REGULAR PLANNING COMMISSION AGENDA

March 26, 2024 at 7:00 PM

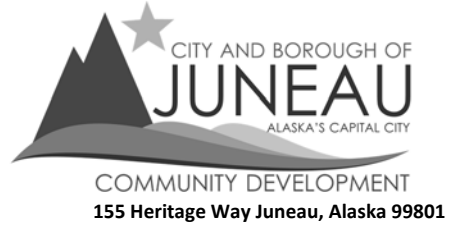
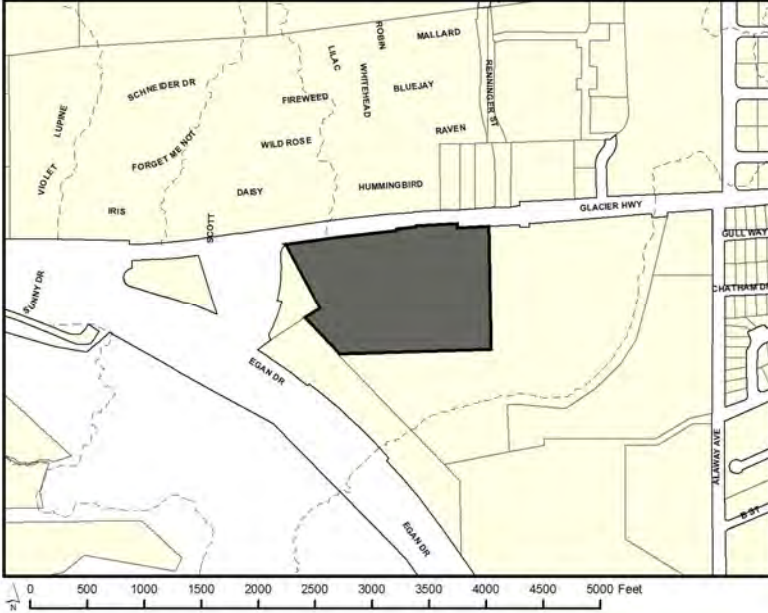
AGENCY COMMENTS:

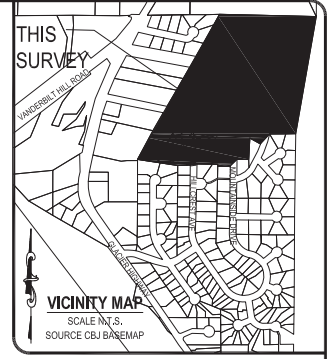
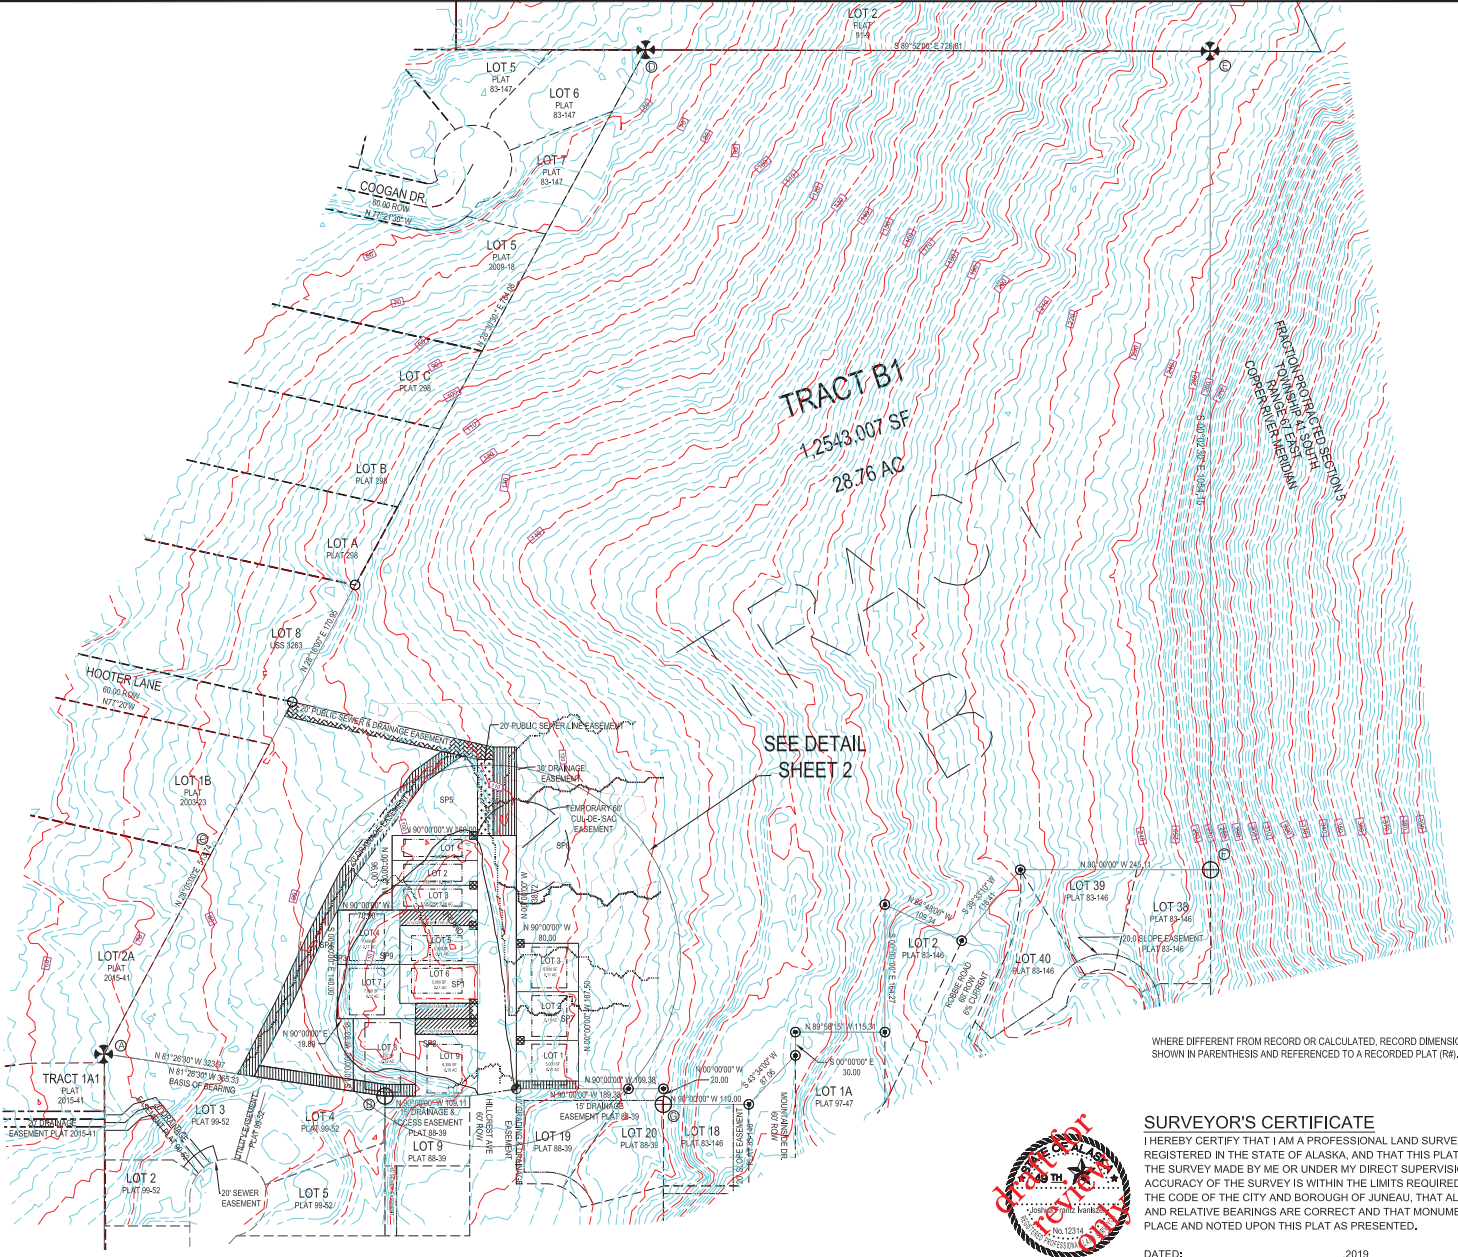
cc: Plan Review

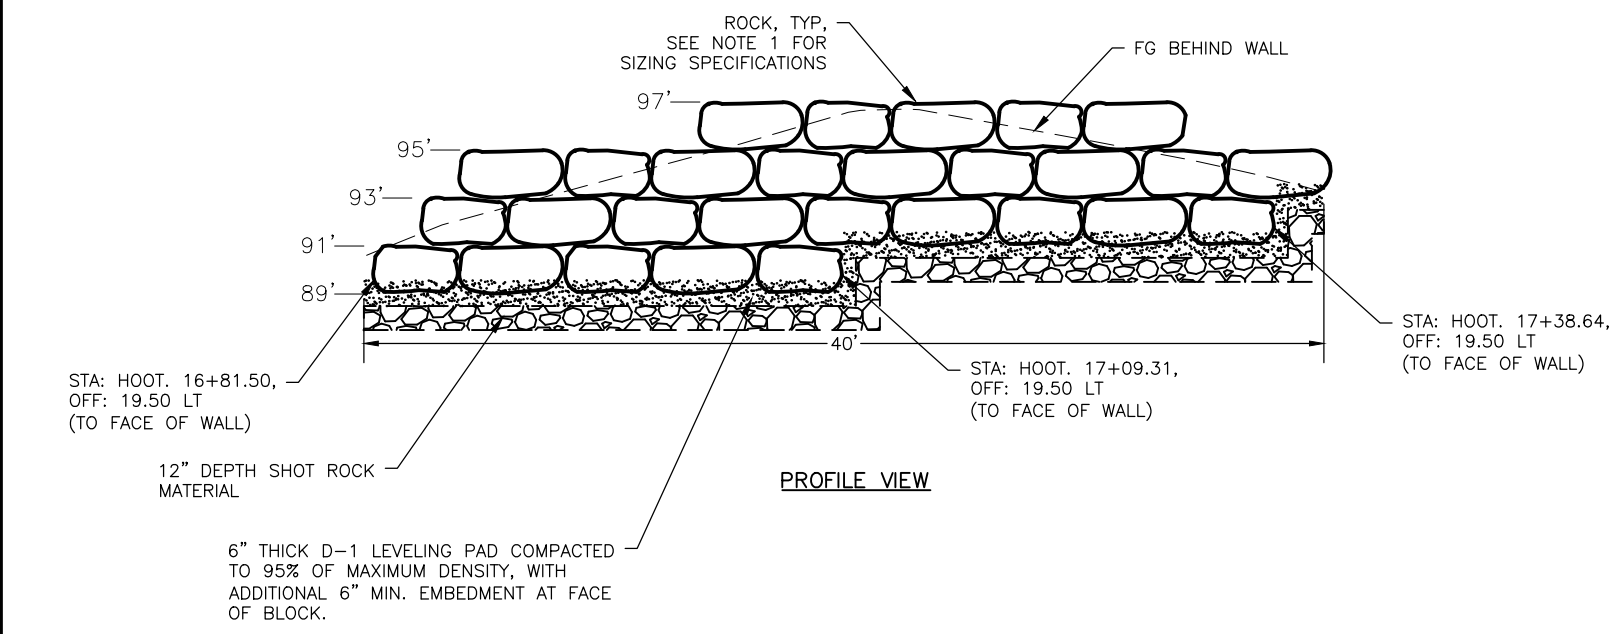
- DETAIL 2/6 NOTES:
1. DETAIL 2/6 IS INTENDED TO SHOW THE TRACER WIRE TERMINATION BOX PER ADDENDUM 16. NO CBJ STANDARDS HAVE BEEN MODIFIED BY THIS DETAIL. ALL OTHER ELEMENTS SHOWN (WATERLINE, WARNING TAPE, ETC.) SHALL BE INSTALLED PER APPLICABLE CBJ STANDARD SPECIFICATIONS AND STANDARD DETAILS.
